2211 SW 4TH

# DESIGN REVIEW SUBMITTAL

abridged revision packet : August 4, 2016

REVISION PACKET

① Option 1 - (south corner shown)  
1/4" = 1'-0"

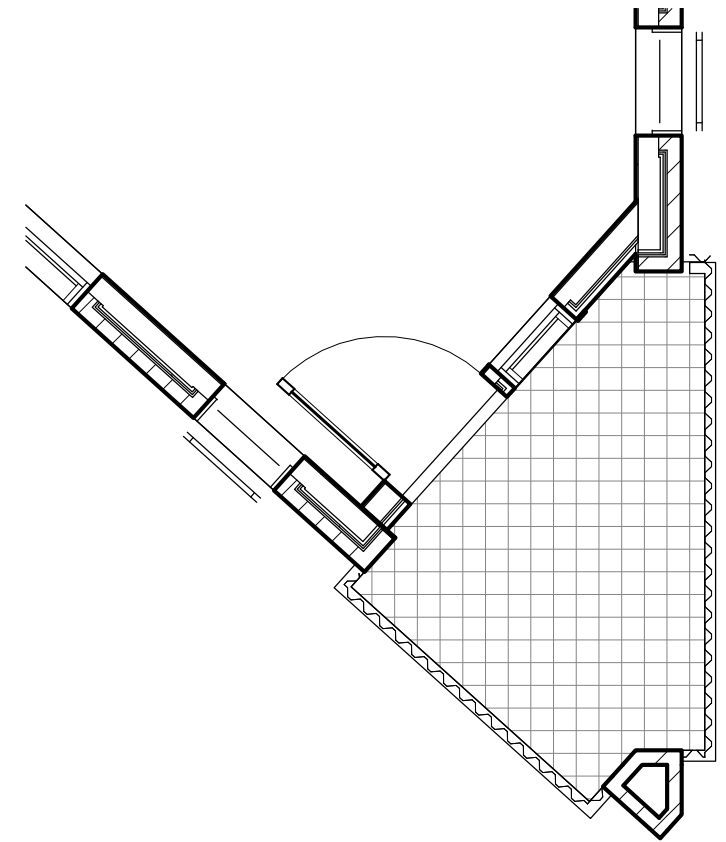
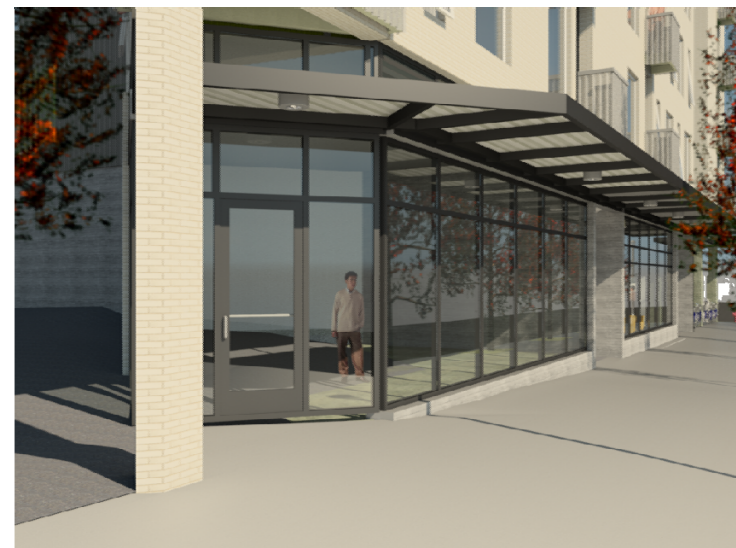
1. Brick corners need further refinement. Bring studies; columns or more dynamic w/o a column.
2. Polycarbonate panel at bike room. Expand on the detailing and whether additional visual glazing would be appropriate.
3. Bike Courtyard landscape plan. This area needs to be designed.
4. Bike entrances and ramp. The gate entry could benefit from additional height for security.
5. Space between 2nd and third floor at NW corner above bike entrance.
6. Pull brick down to grade at SE corner south facing foundation.

Balconies extended to fully express geometry of site and accentuate the dynamic building form. The previously expressed brick column has been greatly reduced in size from the last proposal. The brick connects at each floor level and fully wraps the corner.

Bike Room Structure - Kalwall Clad

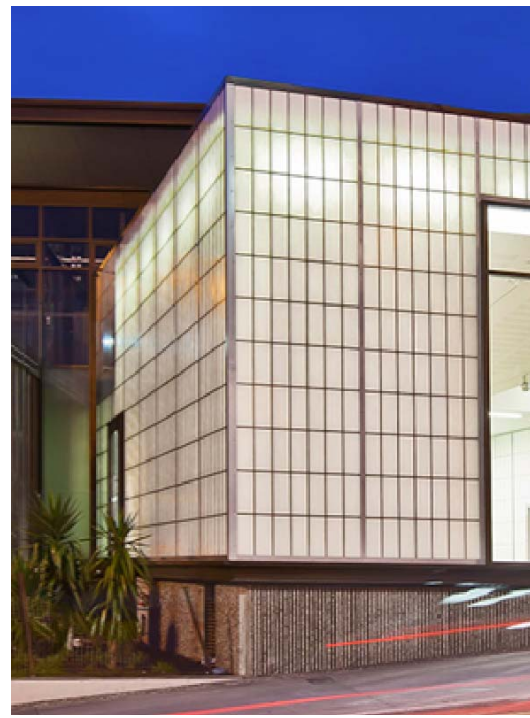
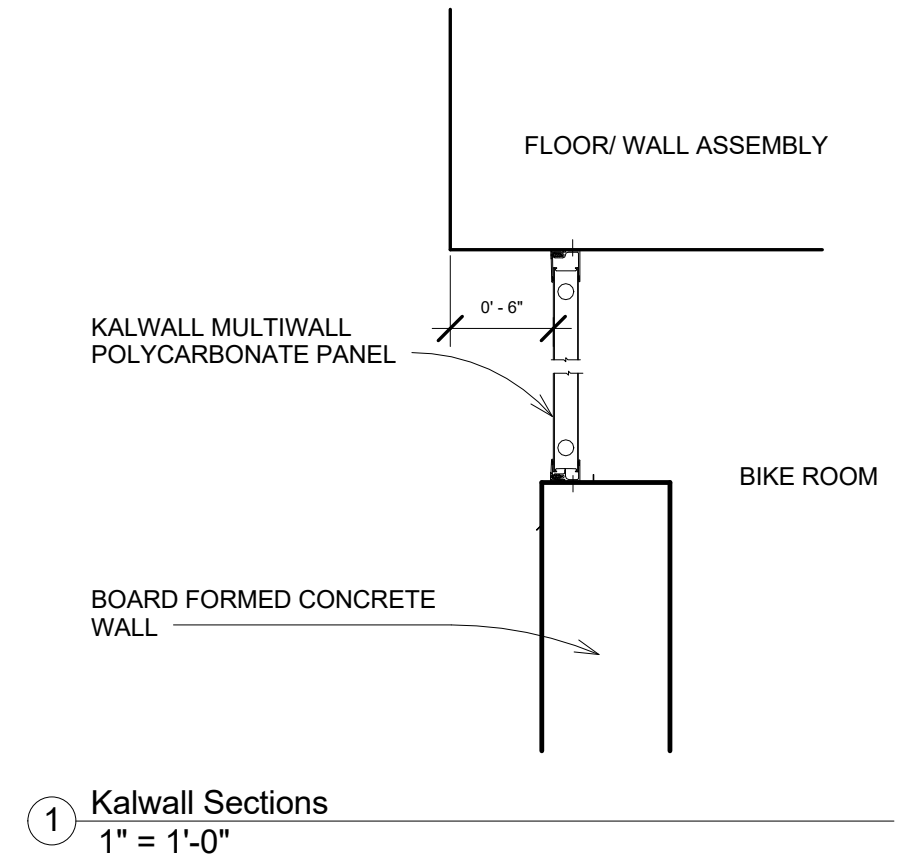
At the commission hearing on July 16, 2016, questions were raised regarding the detailing of the bicycle storage room.

**Additional clarifications, revisions, and imagery have been provided on this sheet.**

1 Bike plaza  
1/16" = 1'-0"

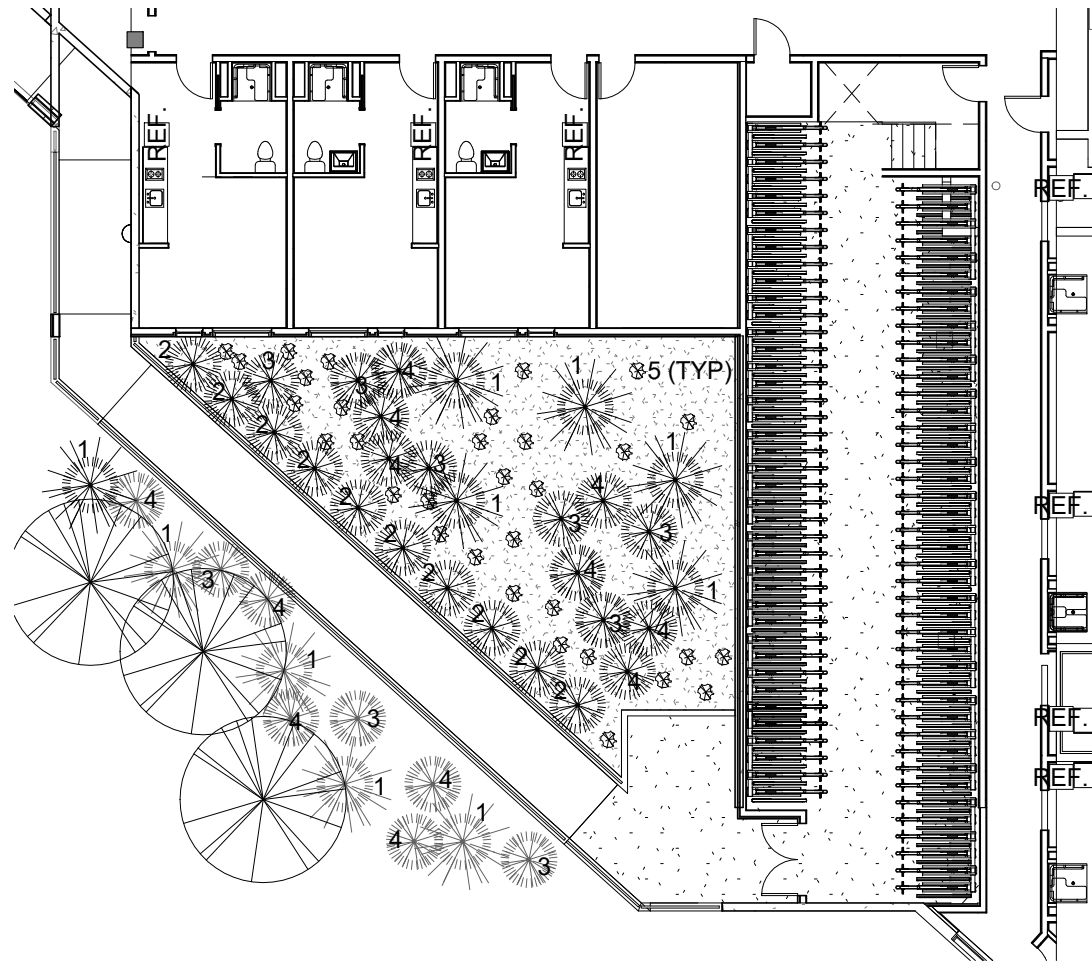
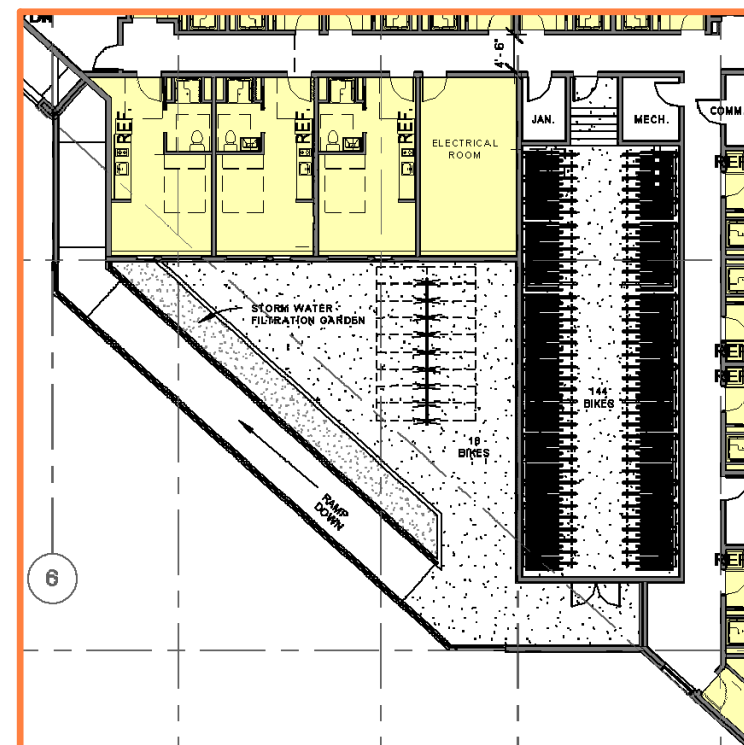
At the commission hearing on July 16, 2016, lack of programmatic detail was seen at the bike plaza area, leading to a concern that the area would not be attractive long term. The rooftop garden area has been expanded and bicycle storage reconfigured to allow all bikes to be housed internally.

The revisions requested have been documented on this sheet.

① Security fence at bike ramp  
1/8" = 1'-0"

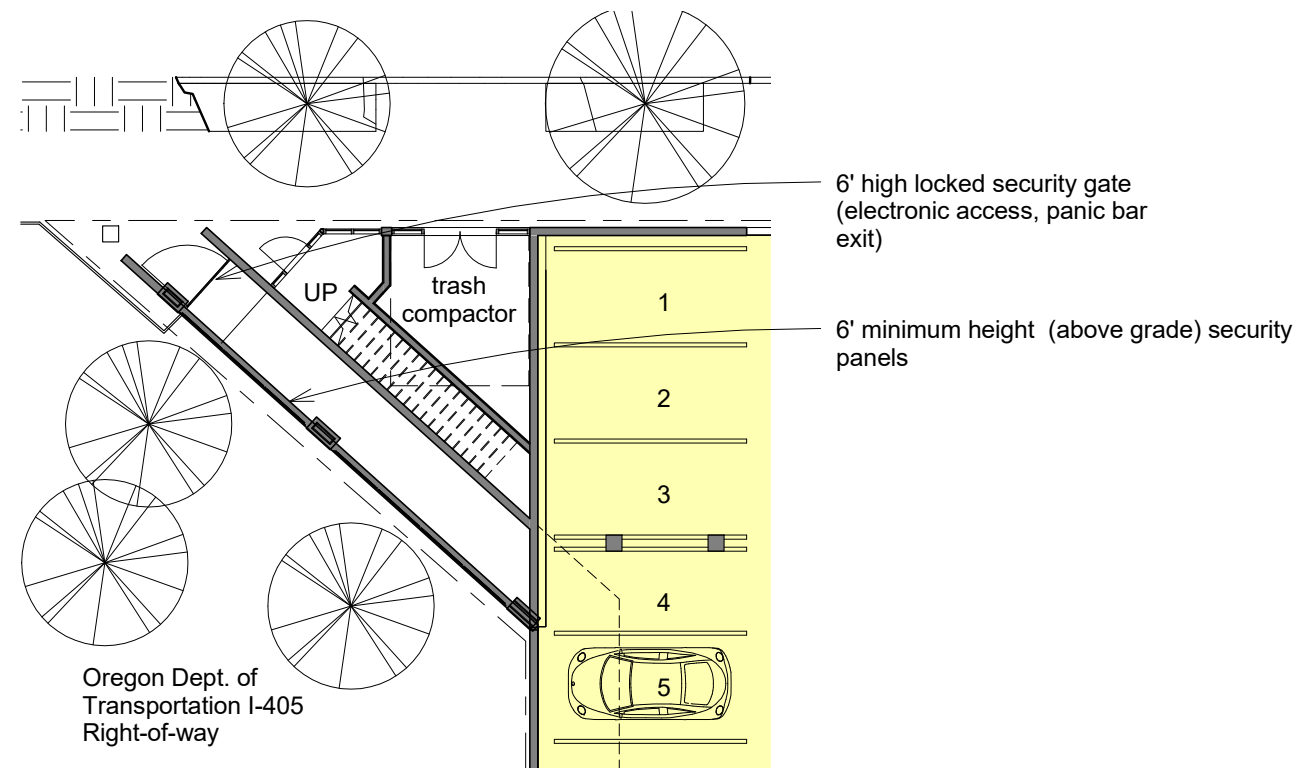
At the commission hearing on July 16, 2016, concern was raised about the security provisions at the bike ramp area. Specifically, the height of barriers and access control was asked to be clarified.

**The clarifications requested have been provided on this sheet.**
